From: Simon Davis
Sent: 05 December 2013 14:10
To: 'Peter Champion'
Subject: RE: Sylvan Way, Bognor Regis - BR/295/13/NMA

Current consented scheme BR/58/13

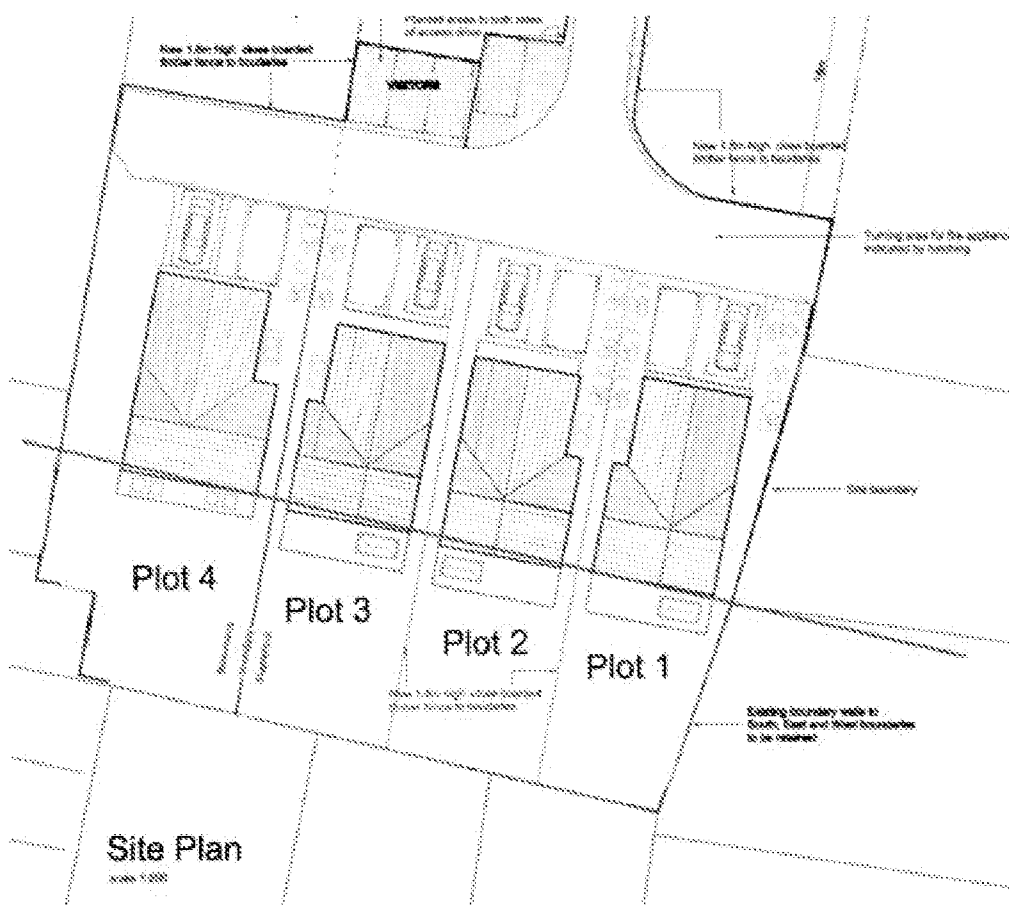
1. Mrs Leeson had thought that plot 4 looked "longer", and she was right that that was an illusion, due to plot 4 (and plot 1) having the cantilevered gable overhang at the front (as per the original consented design).
2. Mrs Leeson said she would like the front walls of the houses to line up, but we agreed it was OK as shown, because the consented scheme had always had the front walls having a slight sequential setting back, from plot 4 to plot 1 (most easily seen by reference to the southern corners of the main roofs, as per the red line I've drawn on this scrap below)

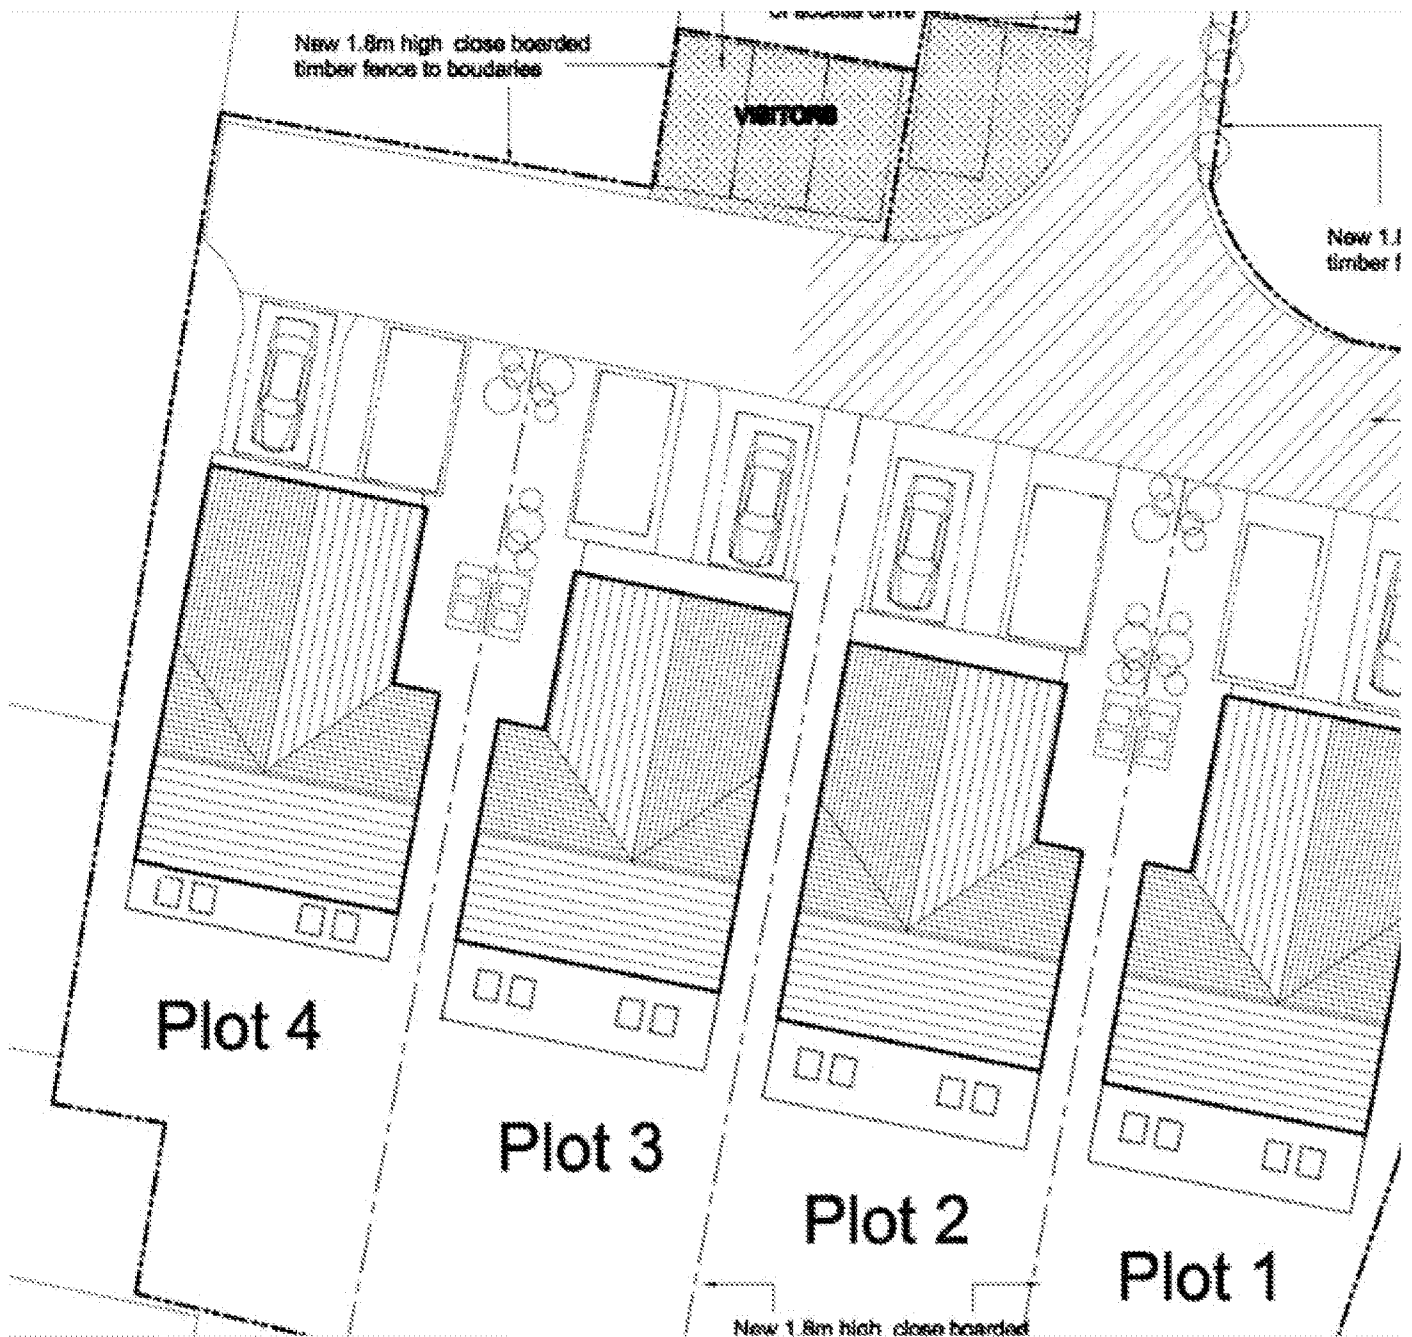
Yes, I agree, but they must both be the same length that is to say to mirror each other. The drawing shows number 4 to be slightly longer, maybe that is just an illusion.

Below is a scrap from the current consented plan, BR/58/13, which shows that the houses, even allowing for those roofs, were never quite lined up, having a slightly progressive set-back going from plot 4 to 1.

I think you'd agree that I ought not to move building 4 back, because of the proximity to, and sight lines from, Sandy Lodge. So would you suggest I leave my current draft plan as it stands (my preference), or would you like me to bring plots 1-3 forward, enough for all 4 front wall faces to line up?

The dwellings should all line up at the front, therefore dwelling 4 should be pulled back.
